A CUMMINS FIELD CAMPAIGN

Subject: X15 Fuel Pump Head Replacement Safety Campaign

Number: C7083

C7083 - X15 Fuel Pump Head Replacement Safety Campaign, Attachment B

4

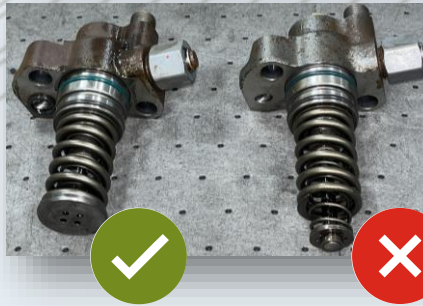
- Verify tappet guide pin engagement. Use your finger to try and rotate the tappet and ensure the alignment pin prevents rotation.
- Verificar unión del pin guía con el tappet. Utilizar su dedo para intentar rotar el tappet y asegurar el pin de alineación previene rotación.
- Vérifiez l'engagement de la goupille de guidage du poussoir. Utilisez votre doigt pour essayer de faire pivoter le poussoir et assurez-vous que la goupille empêche la rotation.
